City of Ferndale
Addendum 1
CRACK SEALING, CITY WIDE
CITY PROJECT NUMBER ST2015-05

ADDENDUM NO. 1
To the Contract Provisions for
CITY OF FERNDAL, WASHINGTON

CRACK SEALING, CITY WIDE
CITY PROJECT NUMBER ST2015-05

DATE 8/11/2015
SHEET 2 of 11

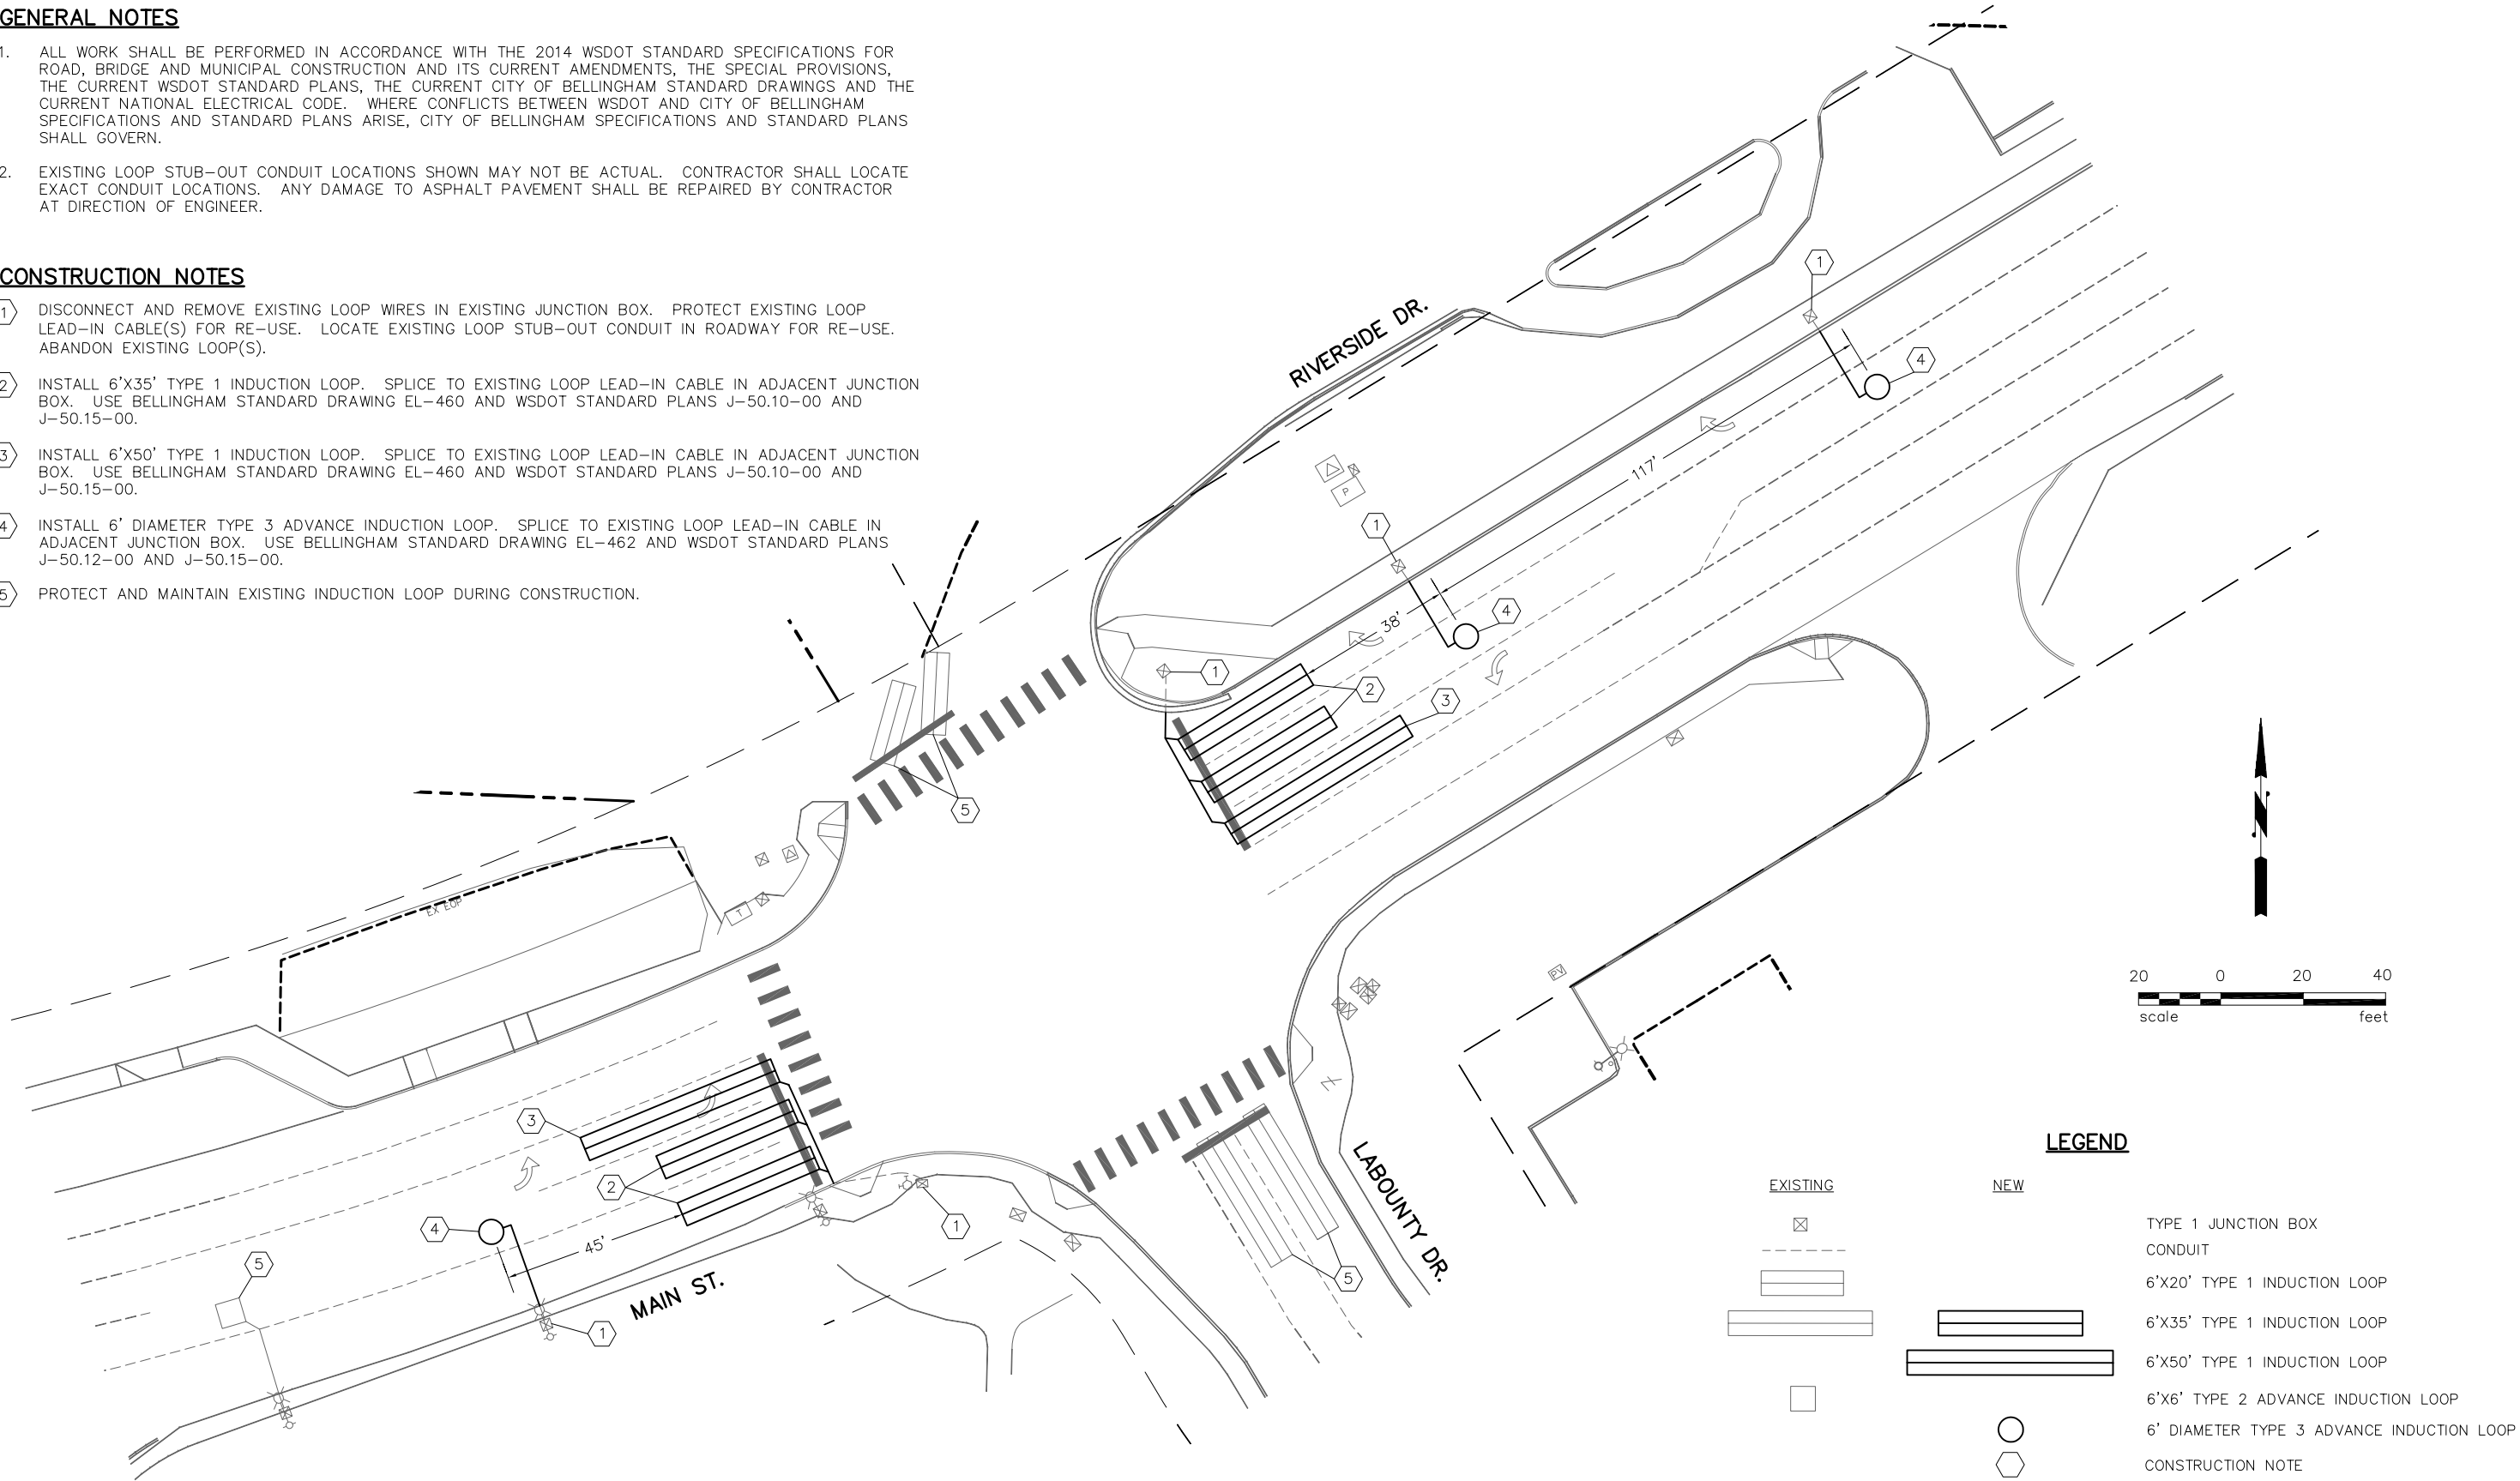
Plan Sheets 2

Approximately 200 feet of additional Gore Stripe (Wide Lane Line) Raised Pavement Markers is shown on the Plans.

NOTE: SSMH AND PROPOSED
GORE STRIPE RPMS BELOW
TRACKS

NO.	DATE	DESCRIPTION	BY
1	8/24/15	GORE STRIPE RPM	LP

CITY OF FERNDALE	WASHINGTON	TS1
CRACK SEALING – CITYWIDE		
MAIN ST./LABOUNTY DR. TRAFFIC SIGNAL MODIFICATION PLAN		SHEET OF SHEETS

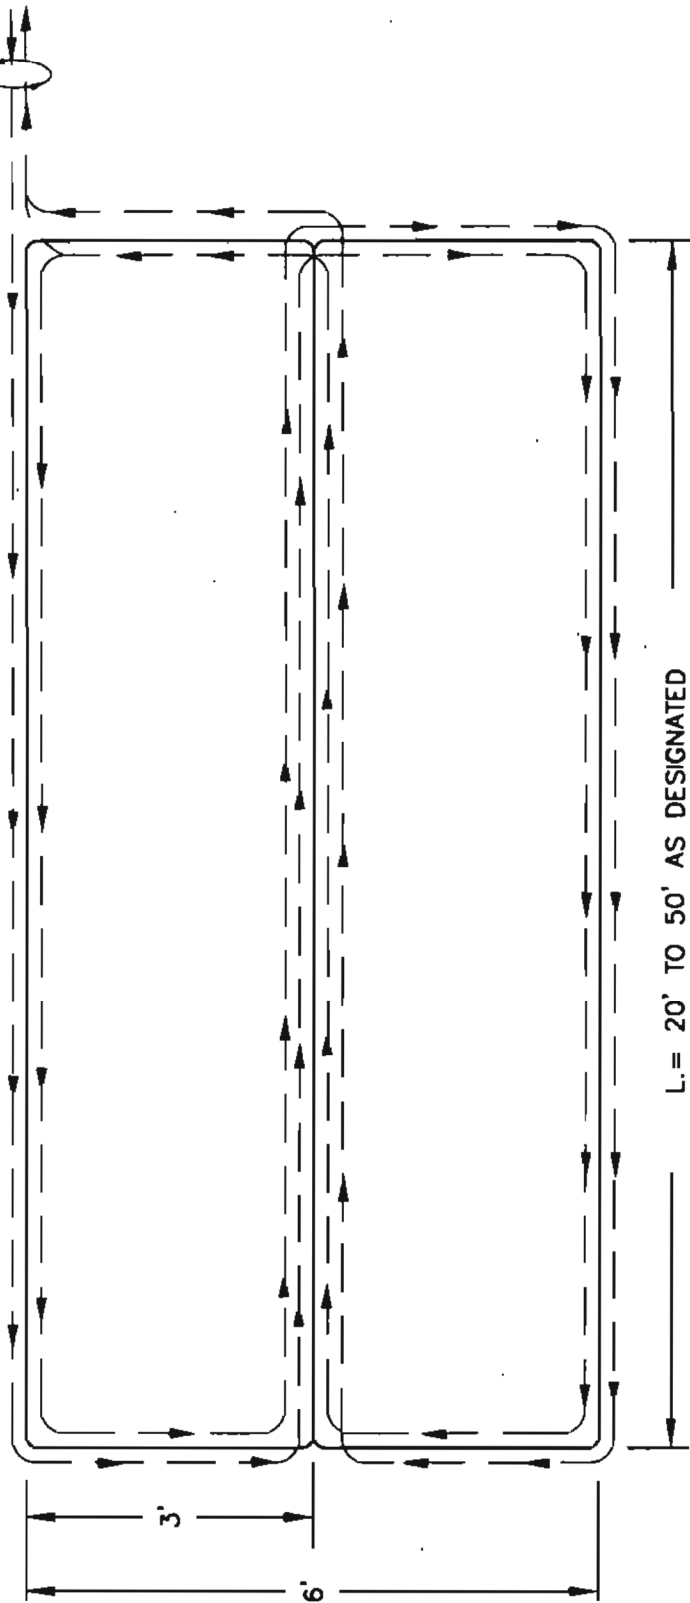
Plan Sheets TS1

The attached Plan Sheet is added to the Contract Documents.
